MAY 2004

ELIMINATION OF ACME FITTINGS AND FILTER CHANGES

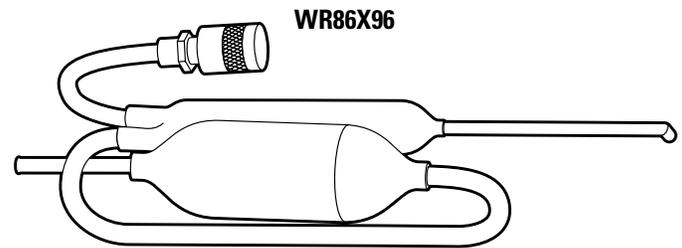
A new "drier only" design is available for most refrigeration sealed system repairs.

When installing the **WR86X93** drier, recharge the system with the **exact** refrigerant charge stated on the name plate.

The installation of only a drier (WR86X93) is approved for all sealed system repairs except in the following situations:

1. Replacing a rotary compressor
2. Compressor burn-out
3. When known contaminants have entered the system.

For these repairs, the installation of a filter drier (WR86X96) with extra filtering capacity is required.

When installing the **WR86X96** filter drier, **add** an additional **1/2 ounce** to the quantity stated on the name plate to compensate for the additional volume of the filter.
